802.1Qav + P802.1Qbv Time-gated Shapers

Norman Finn
Cisco Systems

V01 November 5, 2014

N. Finn's comment on P802.1Qbv D2.1

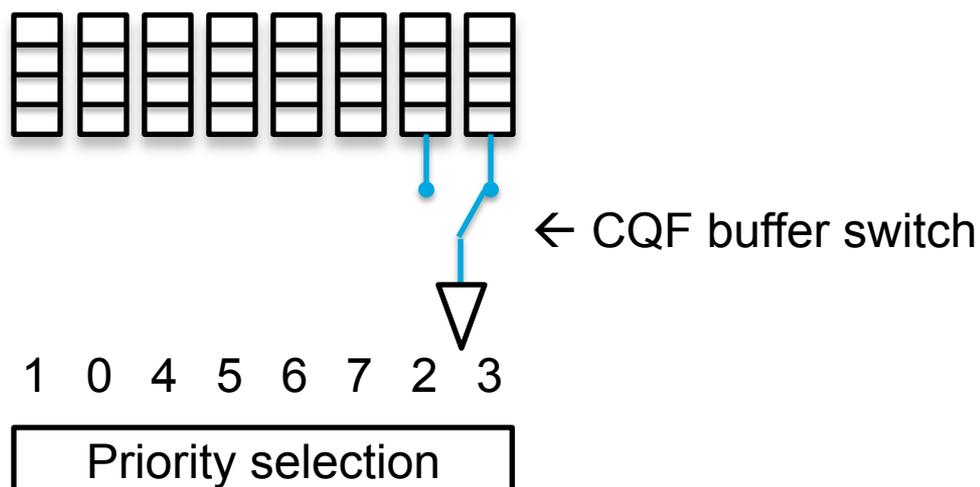
- My comment on P802.1Qbv D2.1 was related to what happens to the AVB shaper when the time gate is turned on or off. You could:
 1. Continue to build up credit when the gate is off.
 2. Freeze credit when the gate is off, except that negative credit builds up to, but not past, 0.
 3. Freeze credit when the gate is off, period.

Oops!

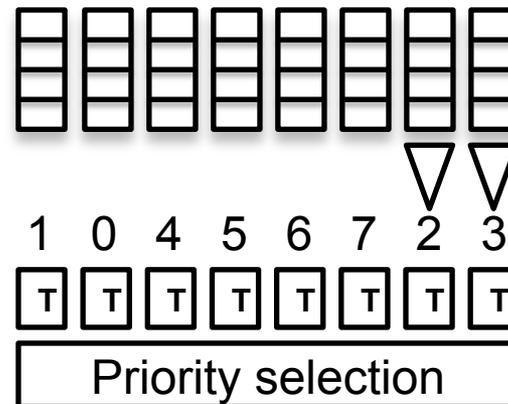
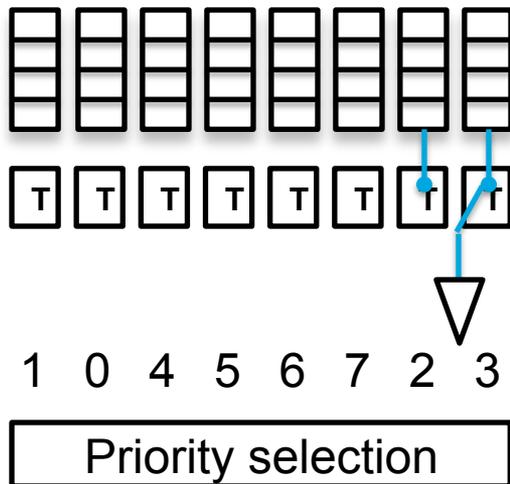
- But now, I have:
 1. Inverted the order of the time gates and the shapers.
 2. Introduced the concept of 2 queues feeding the same shaper.
 3. Begged the question, “What happens if both queues feeding one shaper are turned on at the same time? Do you need another level of priority resolution?”

Hence, my ballot comment on Qbv D2.1

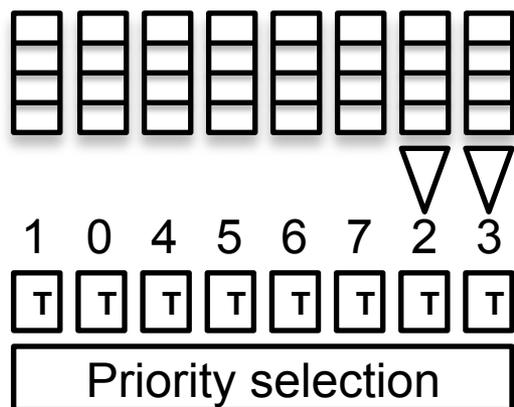
- Given the current state of P802.1Qbv, when CQF switches between queues 2 and 3, the shaper always has enough credit to burst the entire contents of the buffer as if there were no shaper.
- If the credit-based shapers are “frozen” while the time gate is closed, then the current architecture gives me what I want for long-cycle CQF.
